ADDENDUM 01

Addendum to the drawings and specifications for:
Kendall County – Emergency Medical Services Station No. 3

EMERGENCY MEDICAL SERVICES STATION NO.3

10.06.23

A2.5
© 2023 Bealy Palmer Architects, Inc. all rights reserved. no part of this document may be reproduced or utilized in any form without prior written authorization of bealy palmer architects, inc.
BEATY PALMER ARCHITECTS

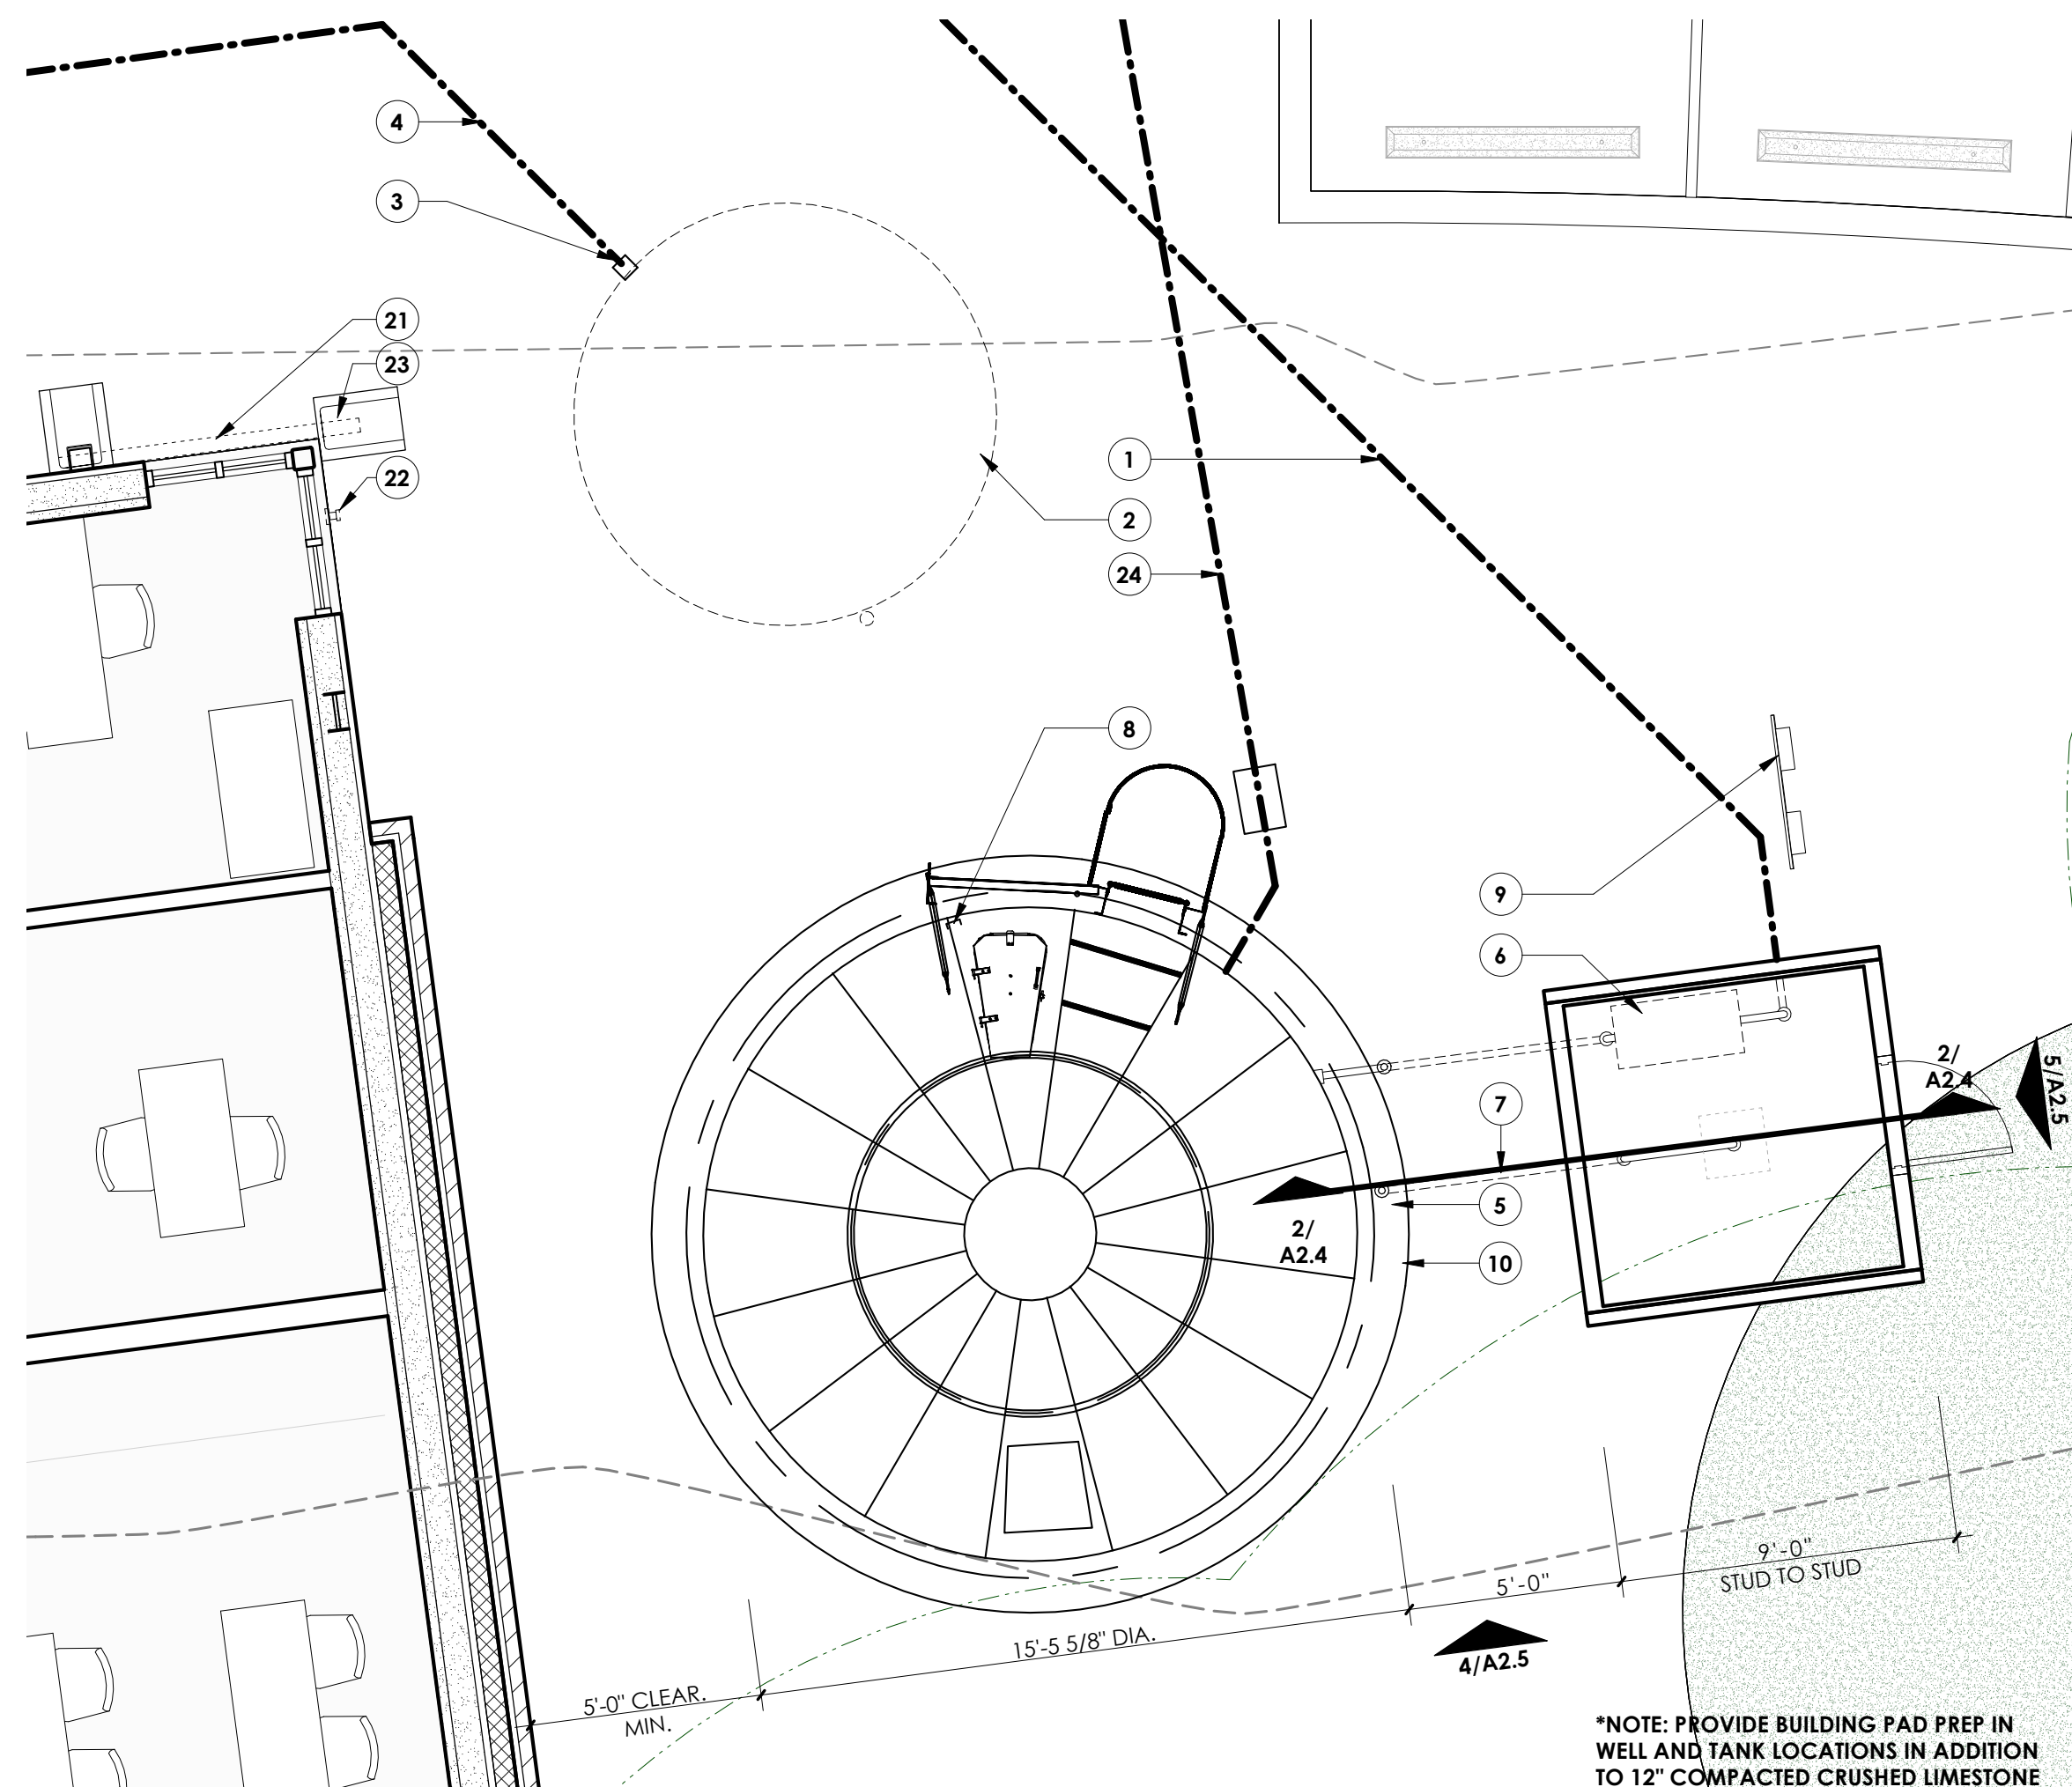
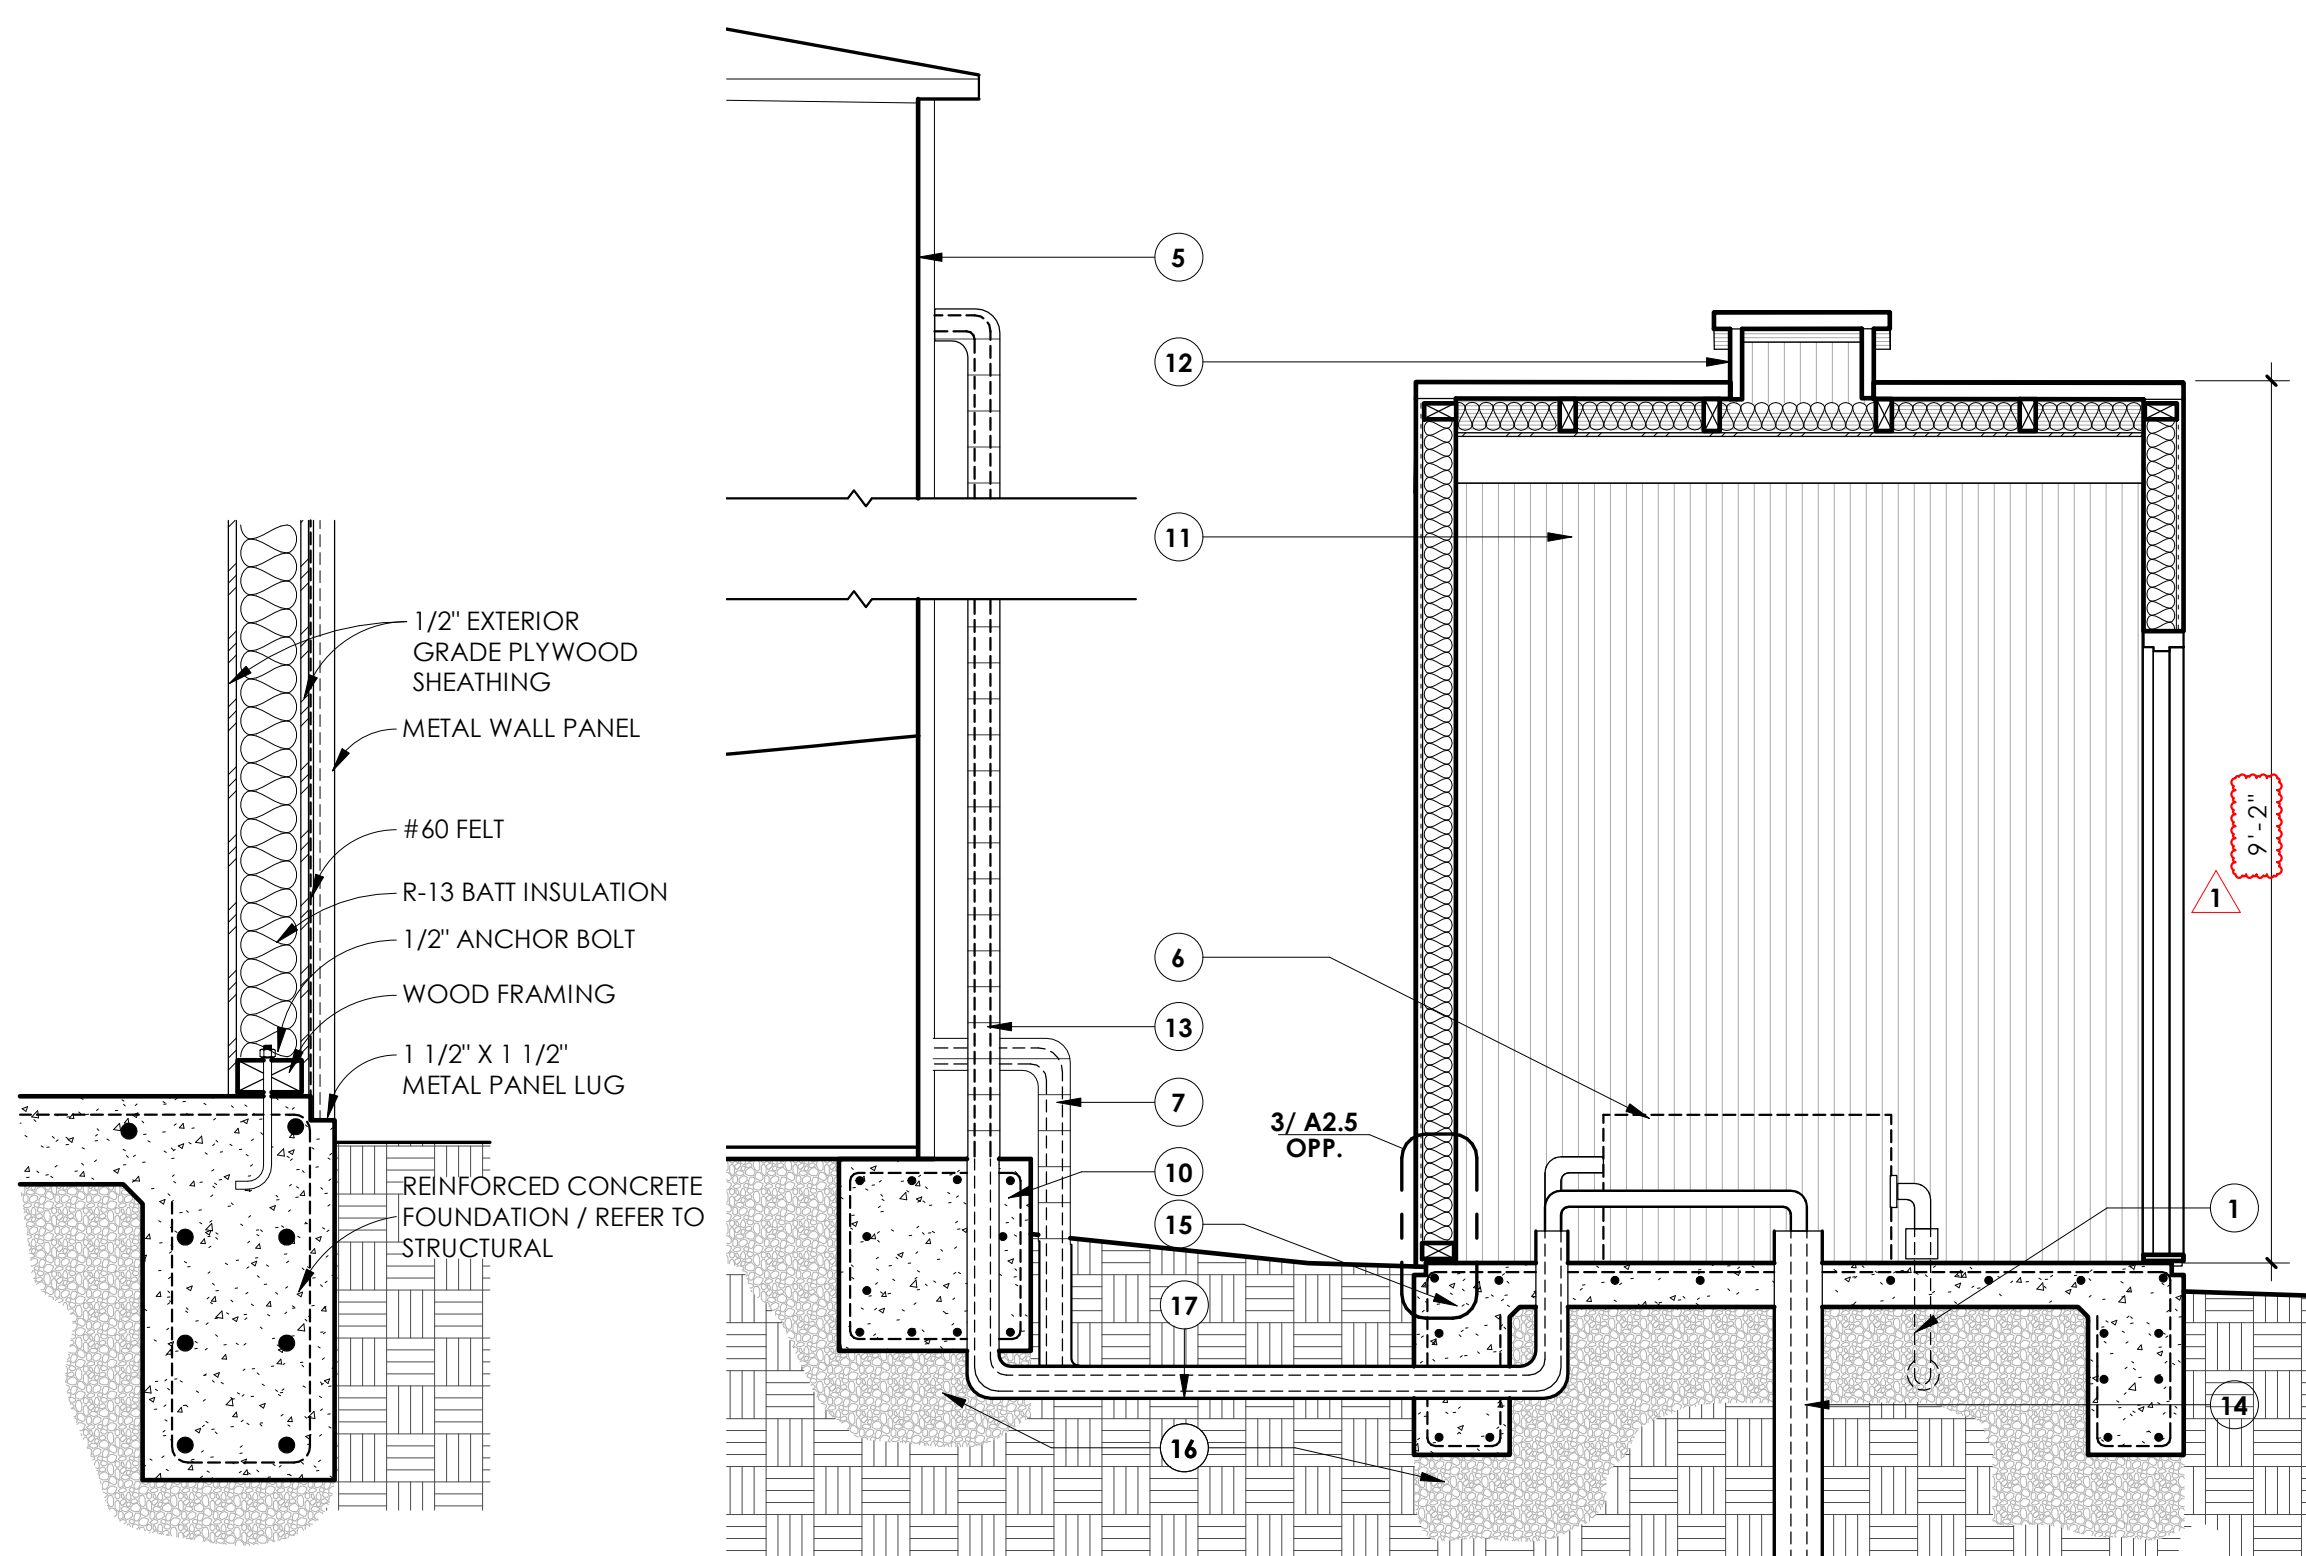
Item 1.10 – Updates Water Well Sheets A2.4 and A2.5

Dimensions on Dog House and Special Water Well Notes updates per water well questions and responses below.

Response to Question 3: *Refer to added dimensions on updated sheet A2.4 & A2.5 for clarification.*

Response: Provide 3 HP Domestic Water Booster Pump with 208 volt single phase power sized to provide 41 gpm at 60 to 70psi. Refer to updated sheets A2.4, A2.5, and E1.0

Response: Yes, provide and install a low water level alarm to be set at 40% capacity of the domestic water tank. Refer to updated sheets A2.4, A2.5,.

layout can be coordinated and confirmed during construction. Refer to updated keynote 23 & 17 on sheet A2.4 , A2.5.
